DOCUMENT 00 91 13 A1

ADDENDUM 1

- A. Bidders are invited to bid on the Construction Contract known as **Rock Canyon Aquifer Storage Booster Station & Transmission Line (PROVOEN202320182), Bid No. 1.**
- B. The location of the work is: Provo Utah
- C. The Work generally includes, but is not limited to, the following:
 - 1. Pump station construction including, all mechanical, electrical, plumbing, structural, civil, and architectural.
 - 2. Pipe connections to existing water mains located at the pump station.
 - 3. Water main construction from the pump station to Rock Canyon.
 - 4. One pipe outlet in Rock Canyon.
 - 5. Two underground vaults.
 - 6. Commissioning of the system.
 - 7. Decommissioning of an existing pump station.

L-01

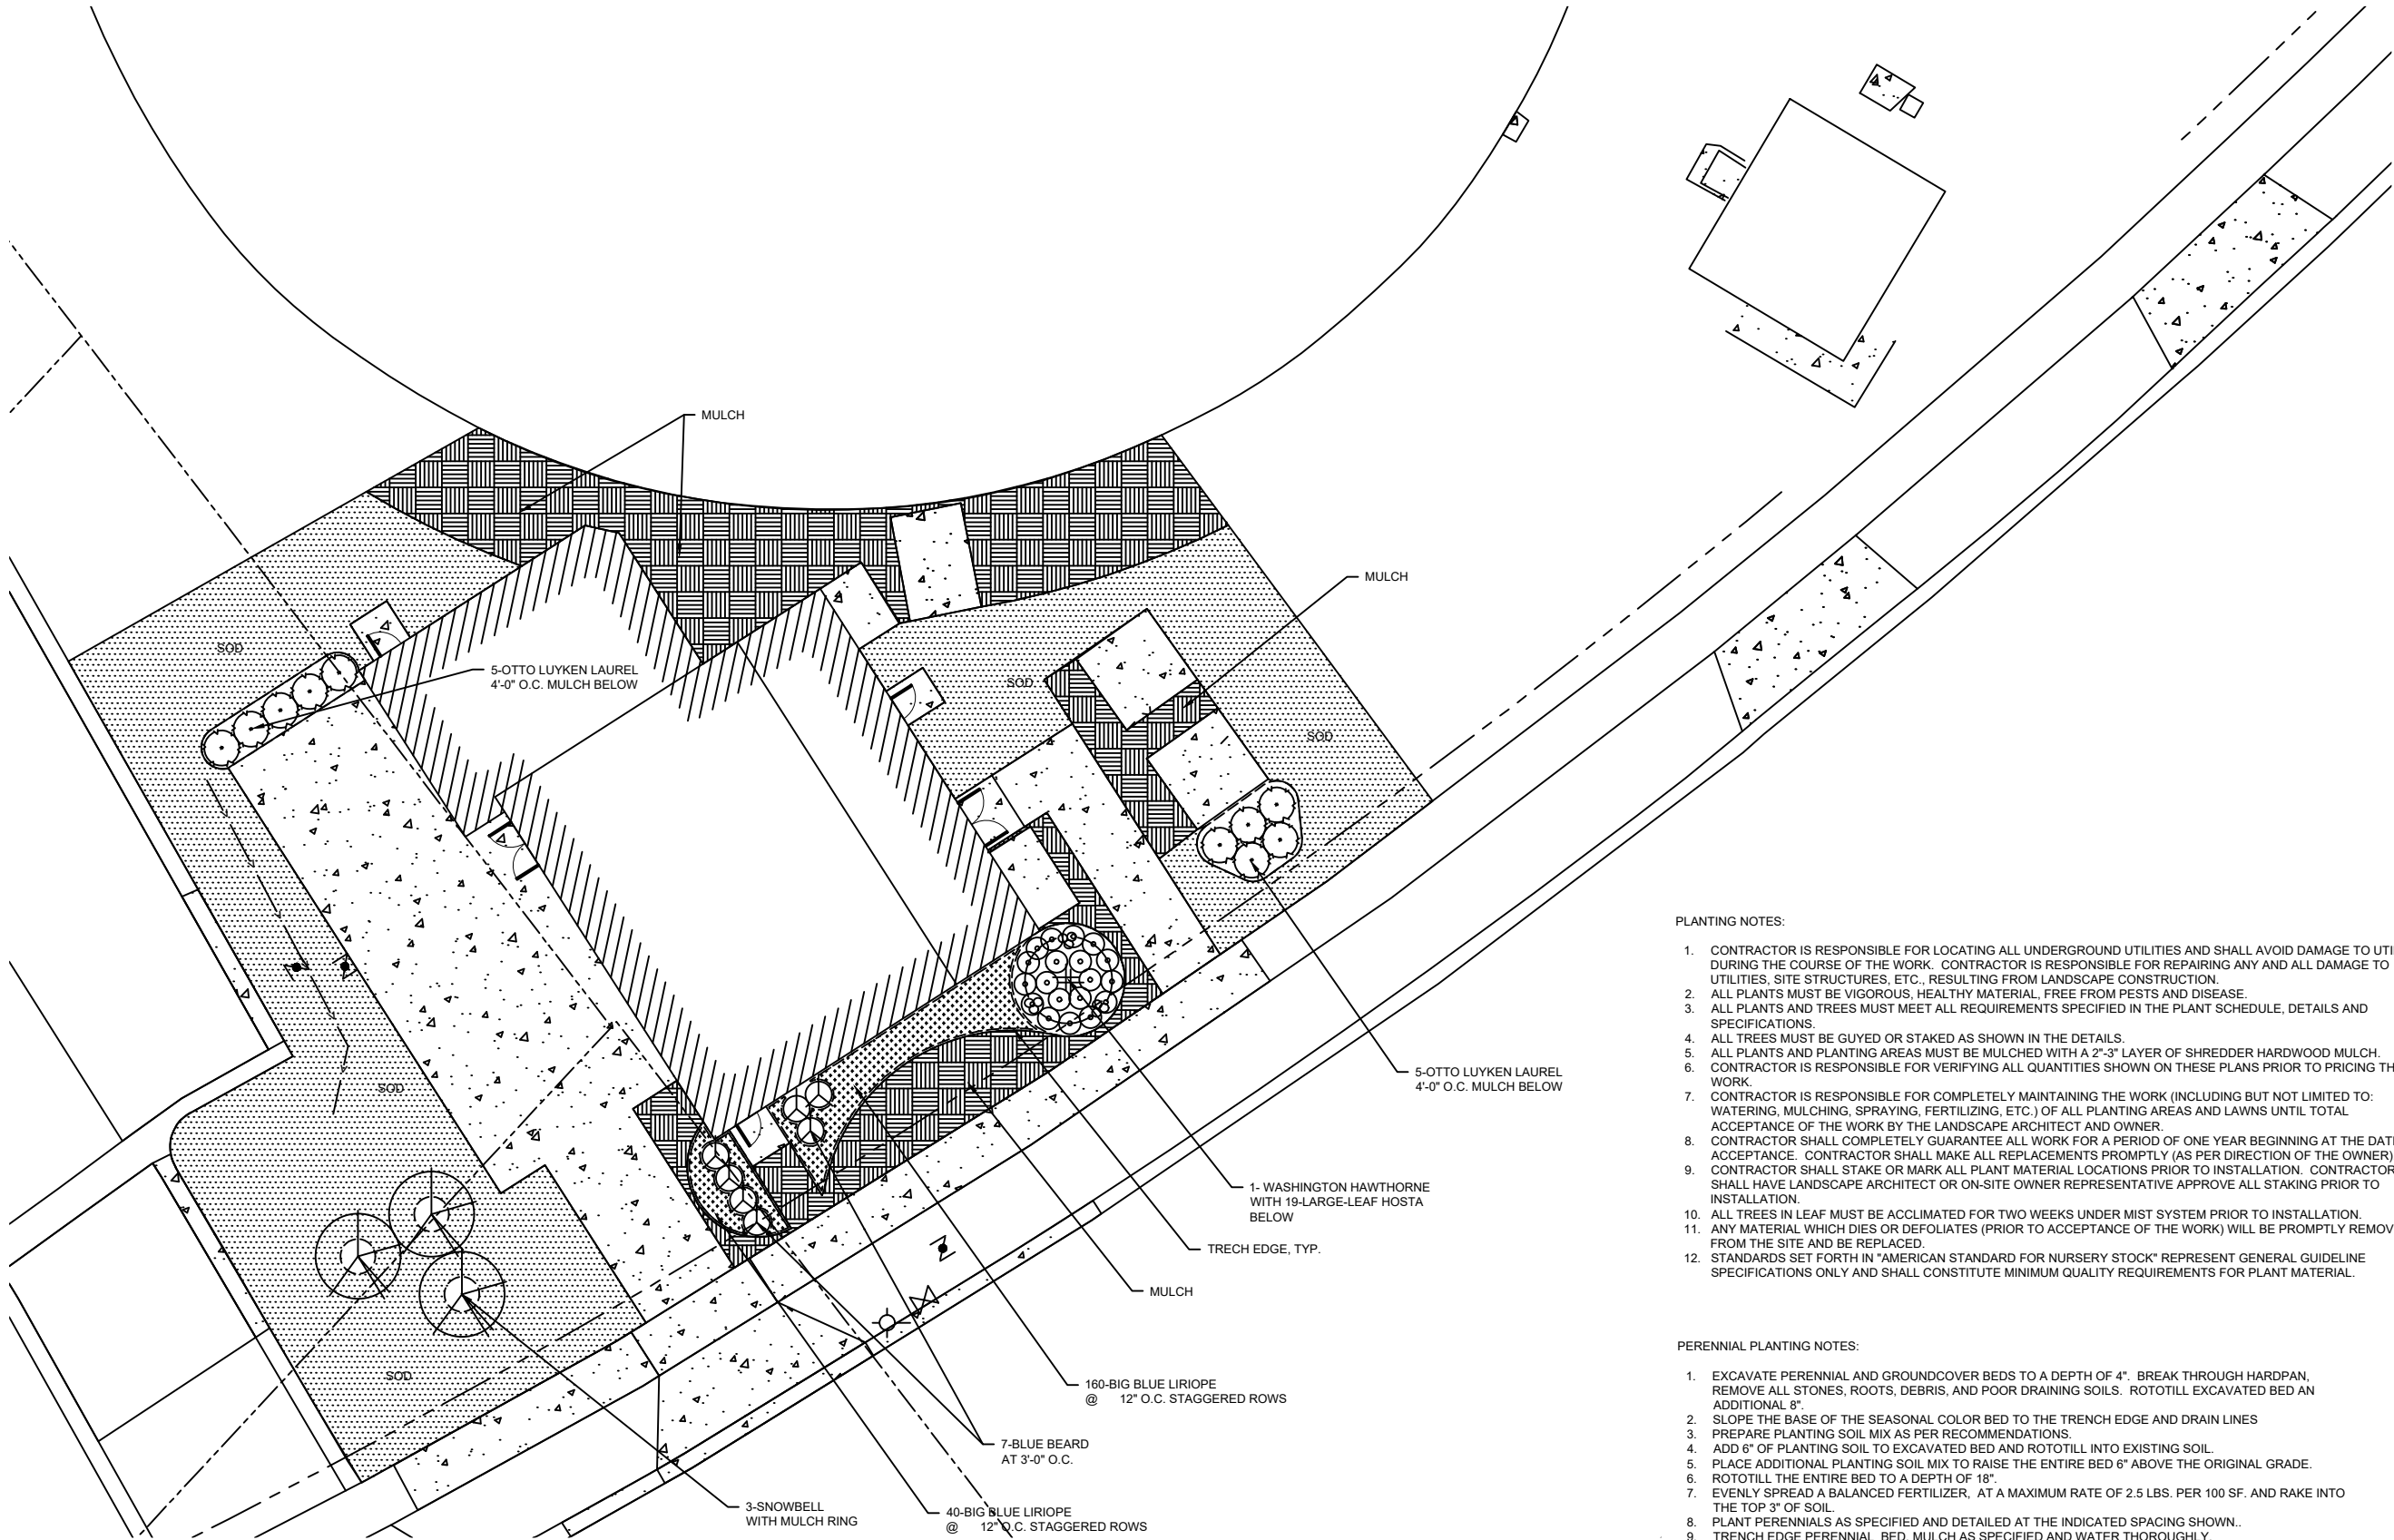
1	07/24/2023	DELETED NOTE 2
A	03/31/2023	ISSUED FOR BID
I/R	DATE	DESCRIPTION
